SECTION 905 -- PROPOSAL (CONTINUED)

| Number | Description |
|--------|---|
| 1 | Revise Table of Contents, replace same; Add NTB Nos 4658, & 4662; Revise Bid Items, replace same; Add or Revise Plan Sheet Nos. 2-3, 5, 8, 11-12, 14, 19, 28, 53, 55, 87, 8001-8004, 8006, 8008-8009, 8011-8013, 8017, 8019, 8027, 8029-8030, 8032, 8034-8037, 8042, 8048-8051, 8053, 8055-8056, 8062, 8068; Amendment EBS Download Required. |

BR-0019-02(041) / 105189301

Bridge Replacements on SR 7 at Bridge Nos. 154.0, 154.8, 155.0, known as Federal Aid Project No. BR-0019-02(041) / 105189301 in Marshall County.

WORKING NUMBER
AB OF 24
SHEET NUMBER
8011

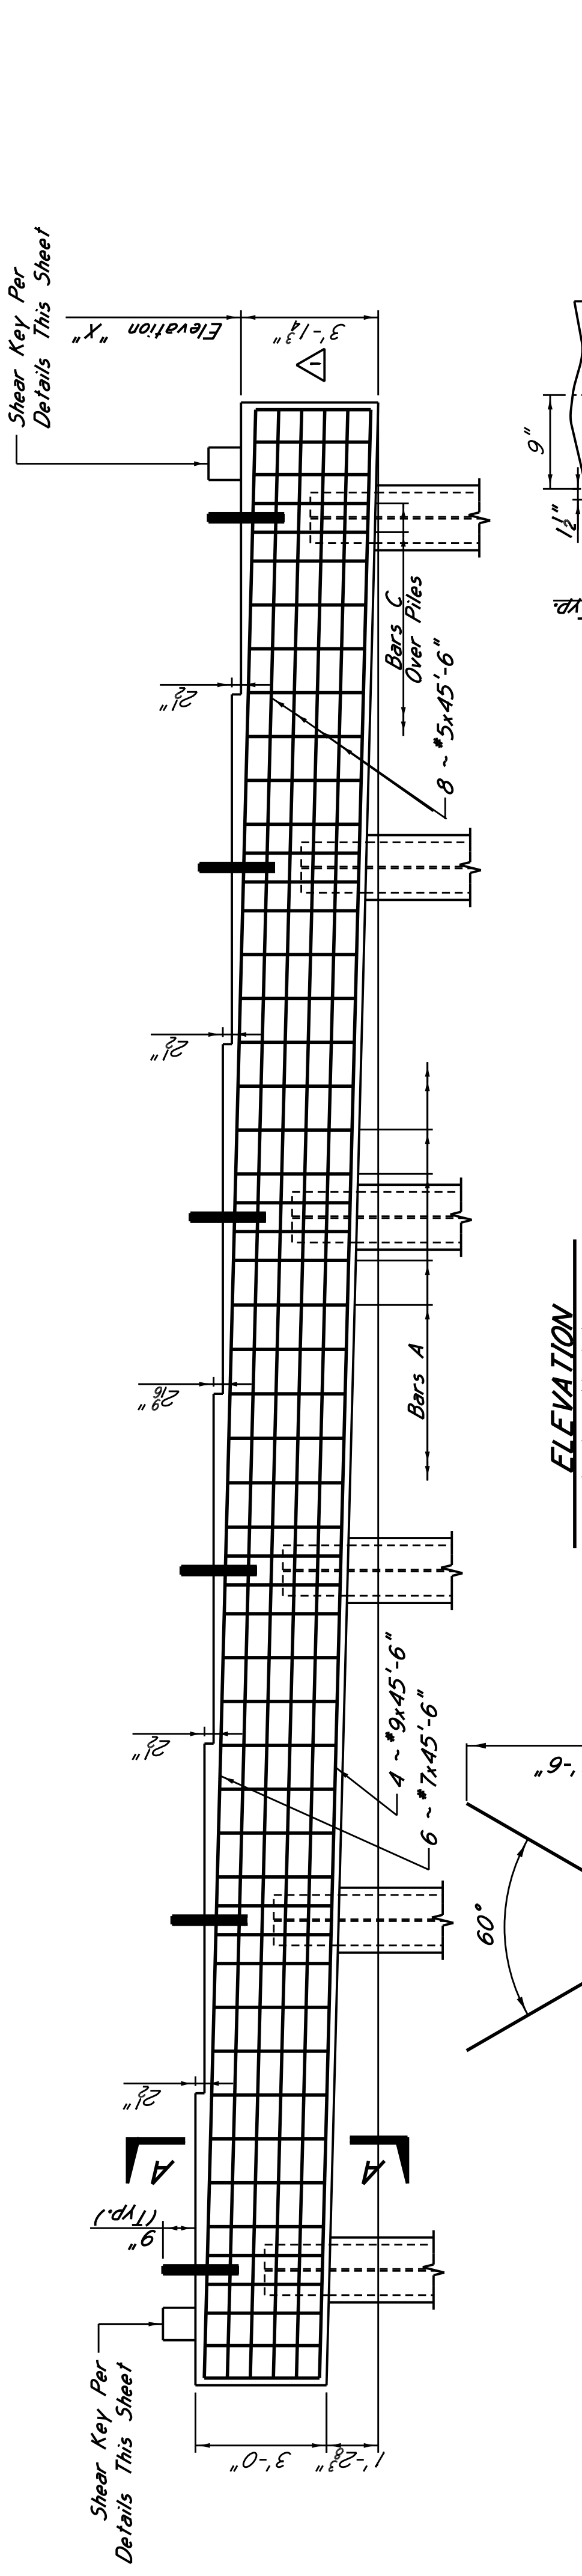
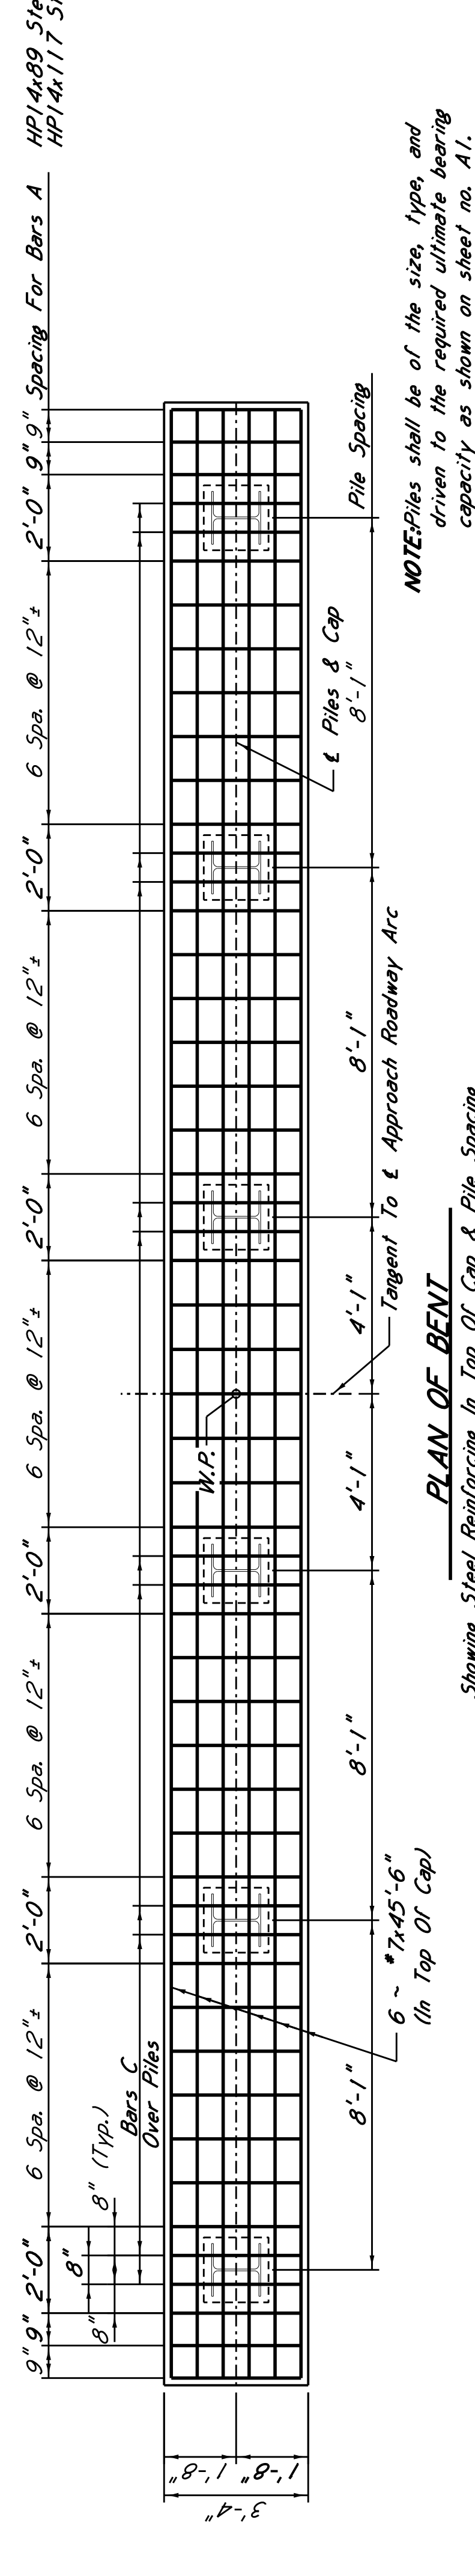
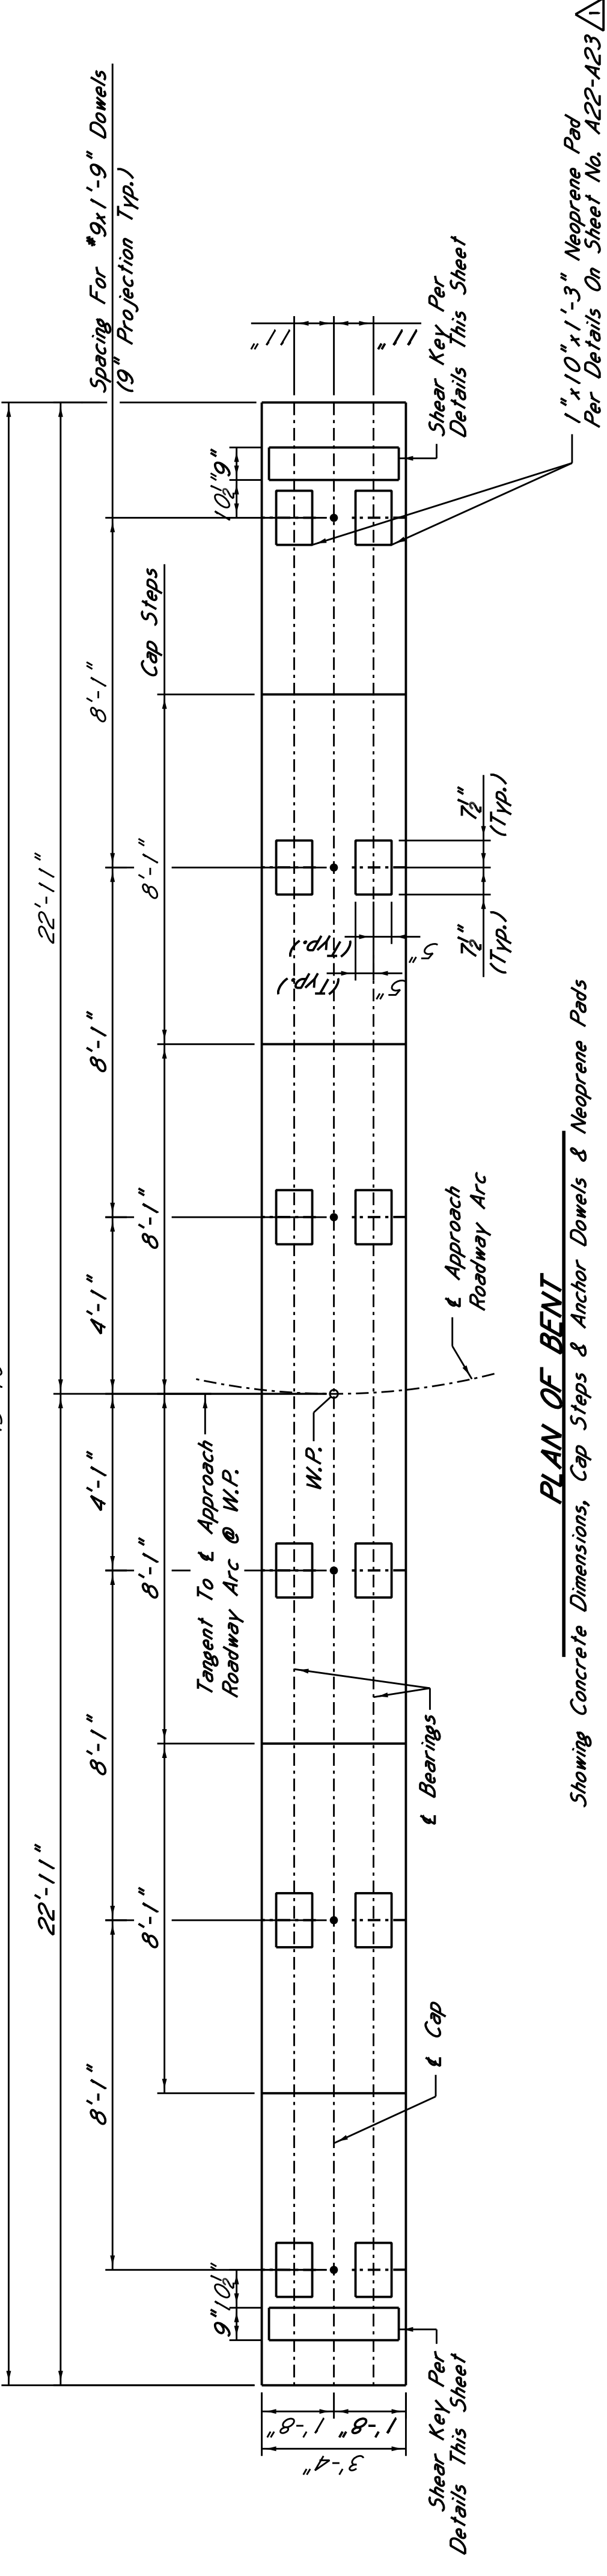
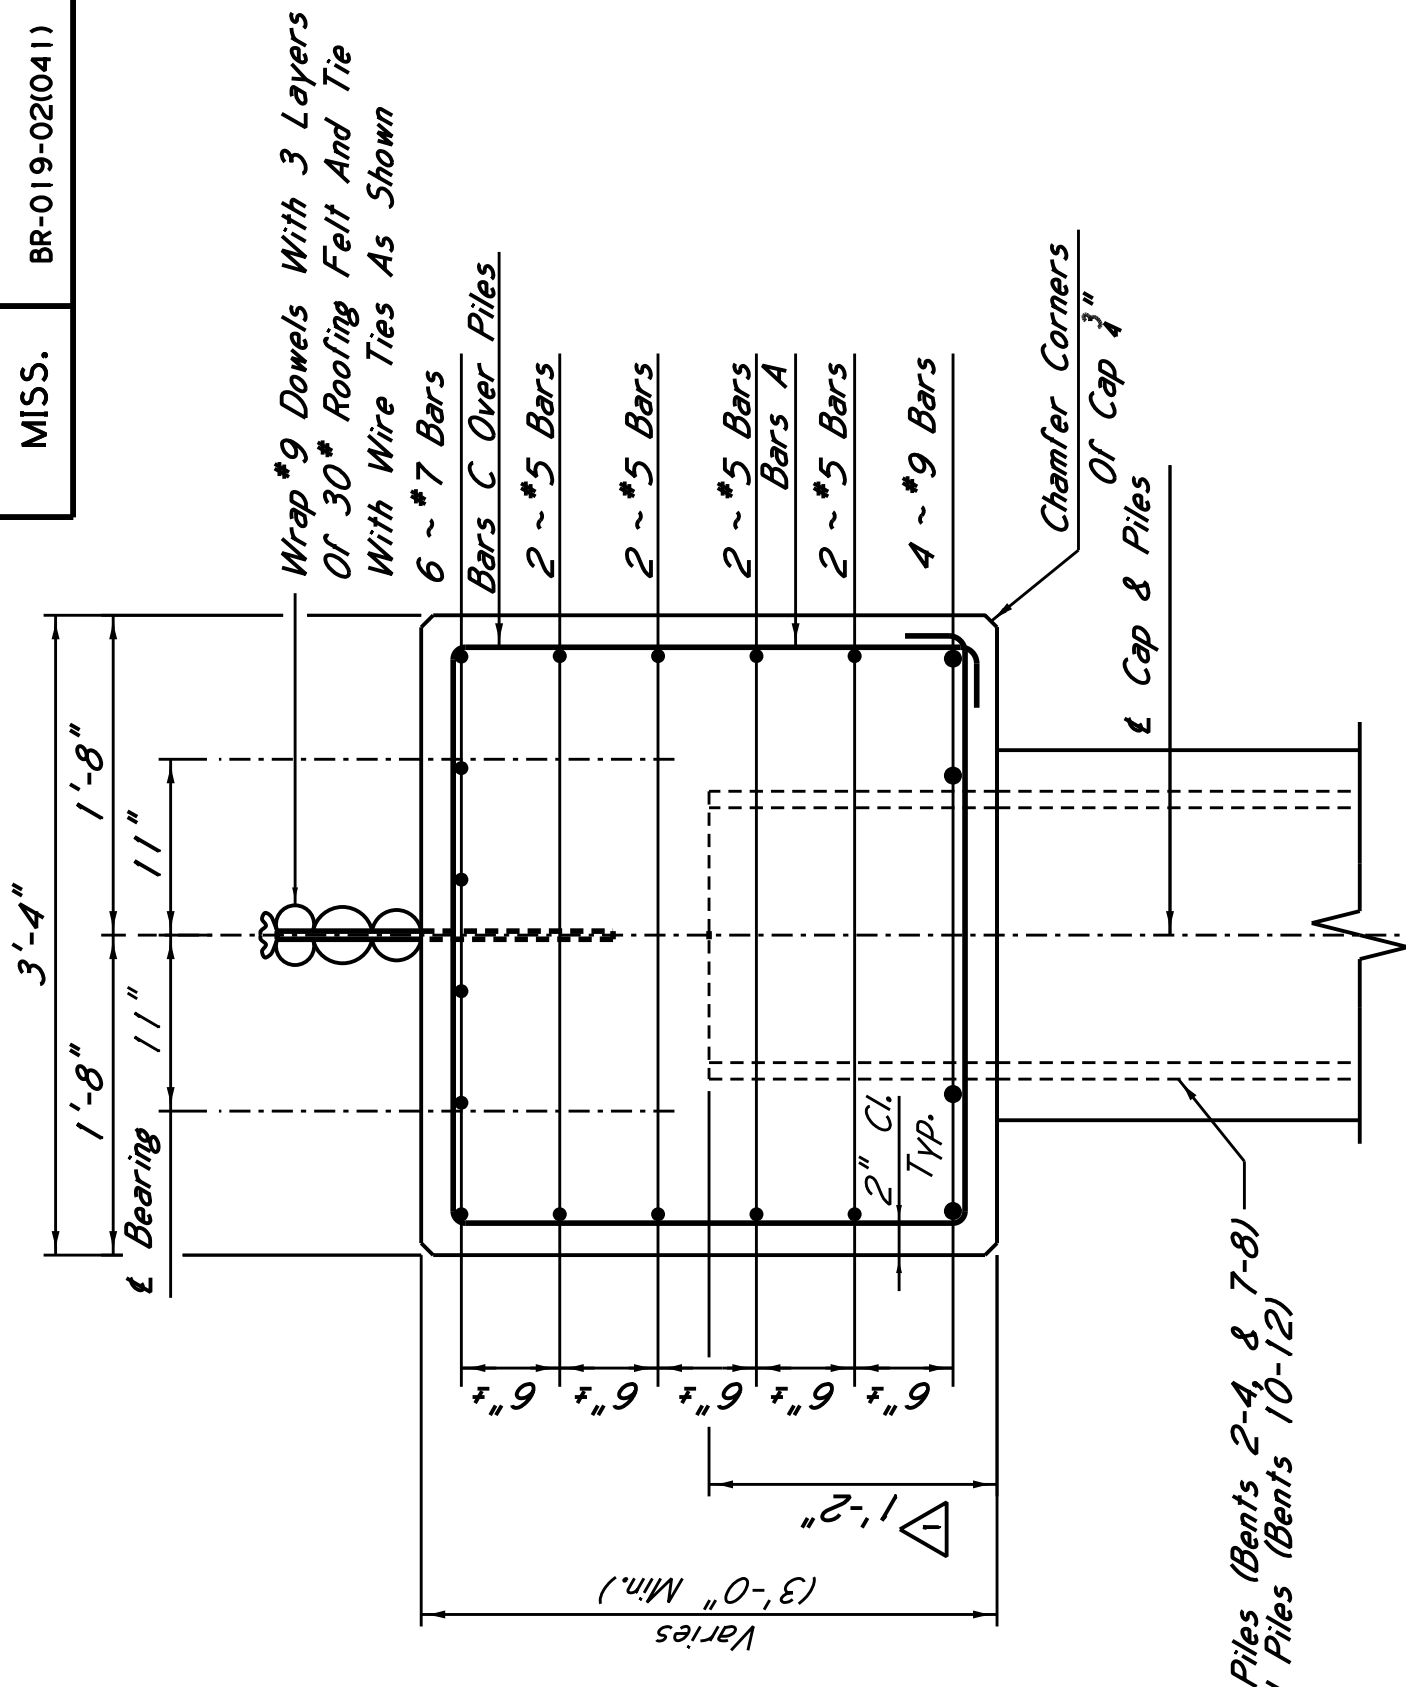
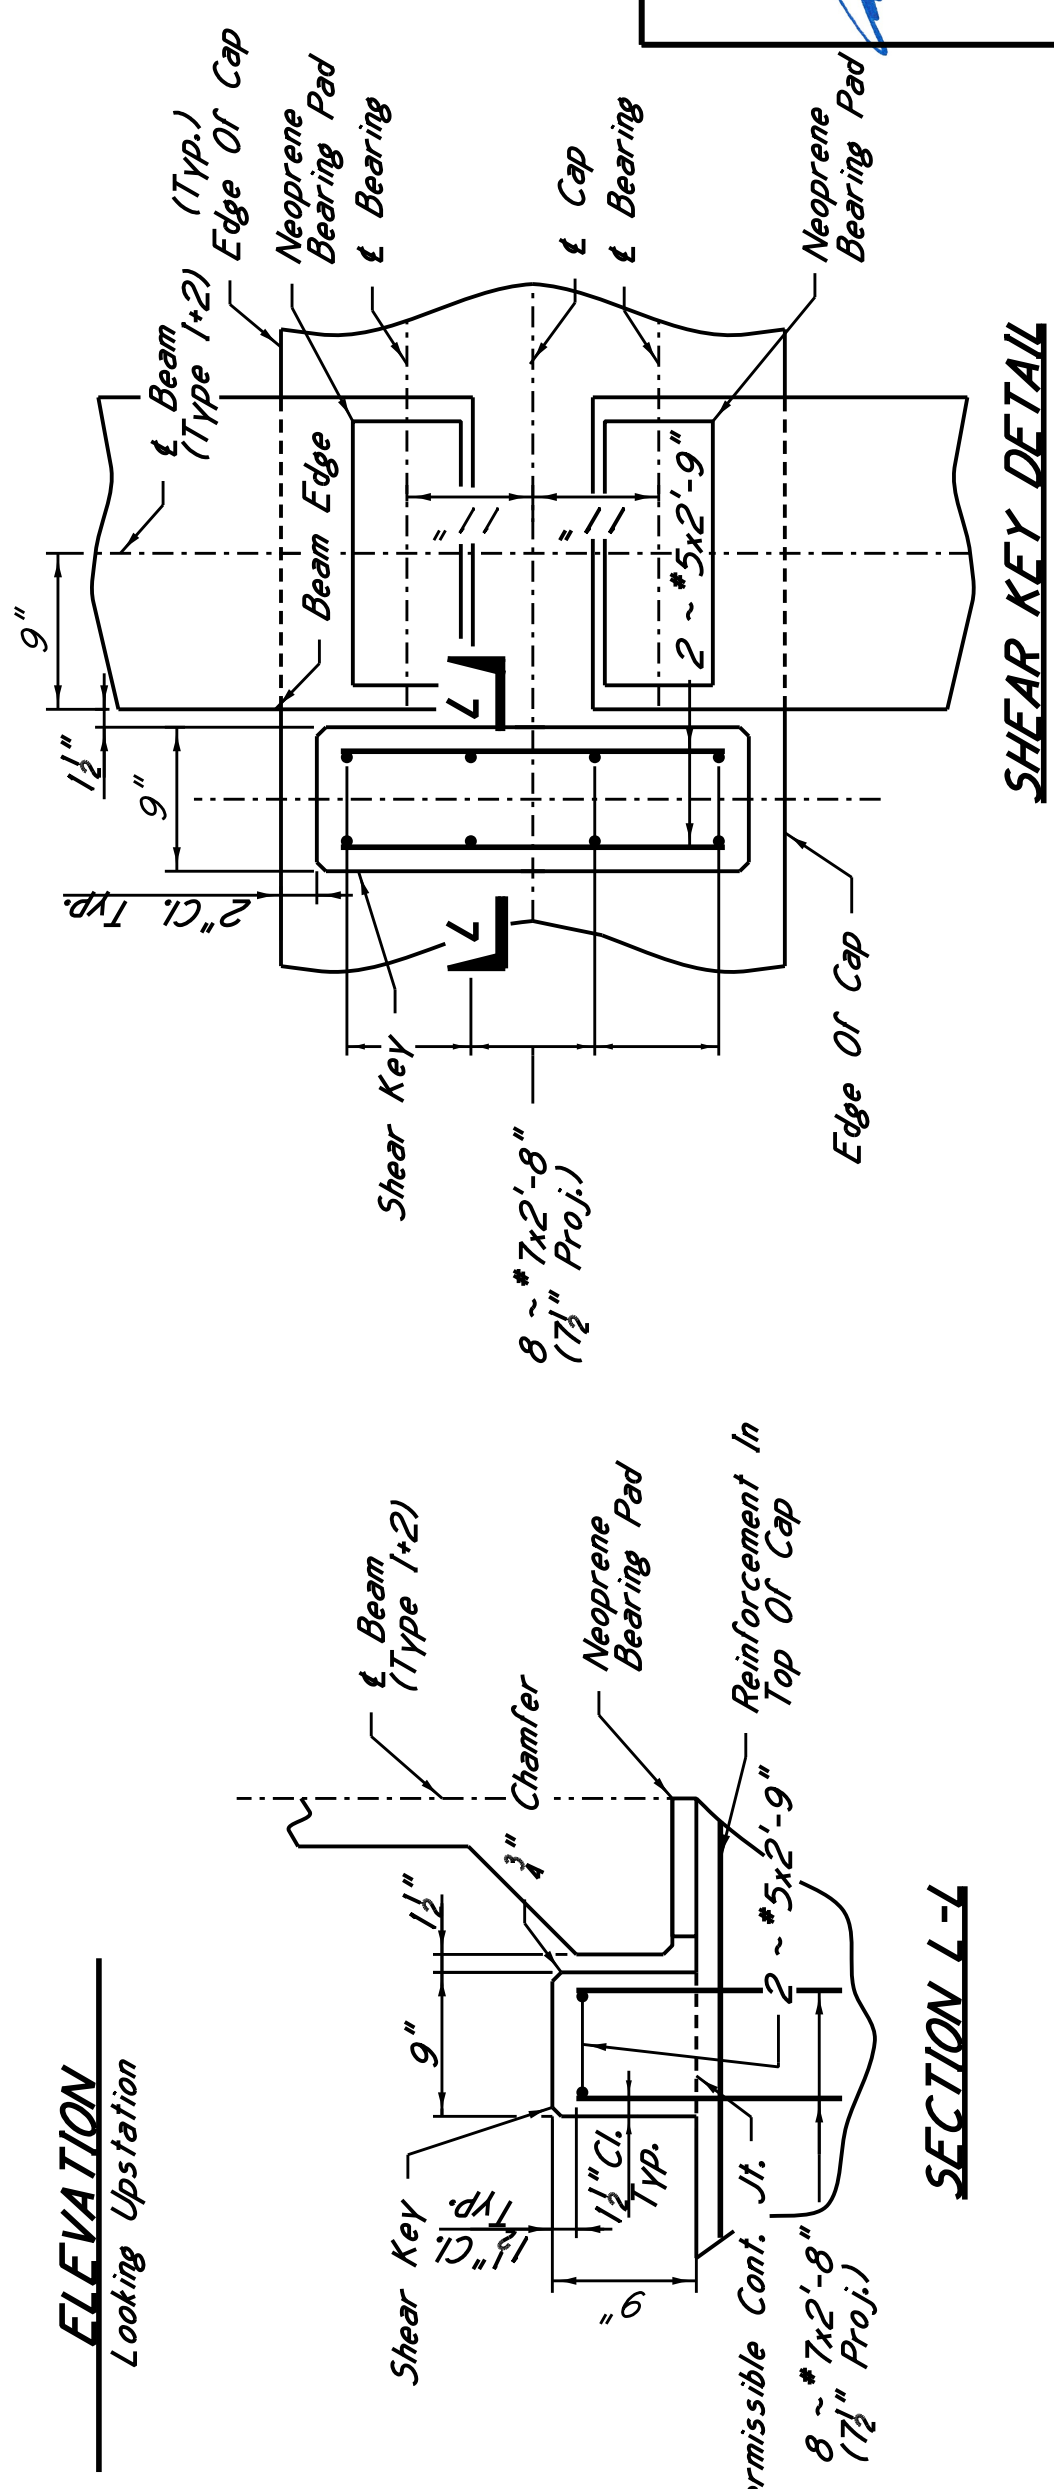
9-12-13 Dimension, elevation & reference revised ECG
REVISIONS
